Newsletter

13.2021

Approval of K35U coupling head

**K30U
S-300kg**

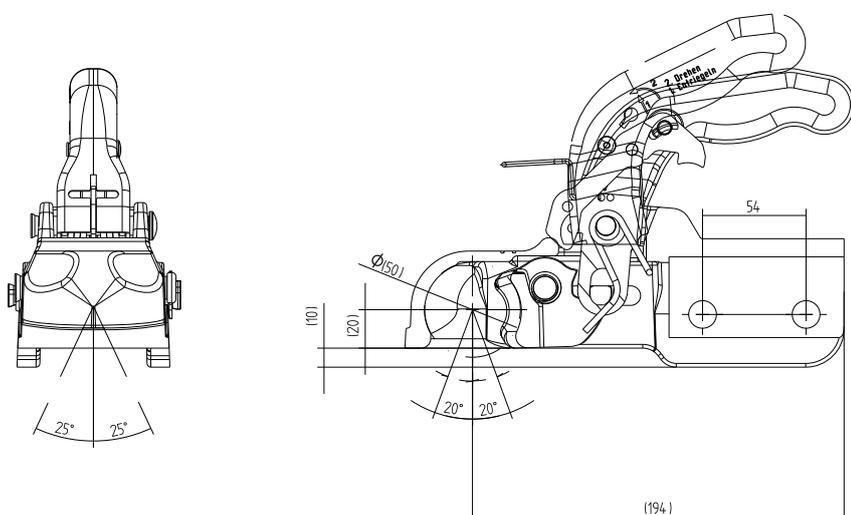
we would like to inform you that the K35U coupling head has been modified and subjected to approval tests. The coupling head is approved for trailers up to 3000 kg. The changes that have recently been introduced in the new version of the ECE R55 Regulation (version 02) force the manufacturer to change the product marking taking into account the extension number.

Therefore, we would like to inform you about the change of the approval number that will soon appear on the K30U coupling head offered by our company.

The coupling head will be offered with the old approval number until stocks are available, and new production will take place with a new marking in accordance with the new guidelines for marking products approved in accordance with Regulation R55

In connection with the change of the approval number, please check whether it does not require any changes to the FTL approval.

E1 55R02/01*2507*01

B50X S-300kg

D/DC 27.00

DMC 3000kg
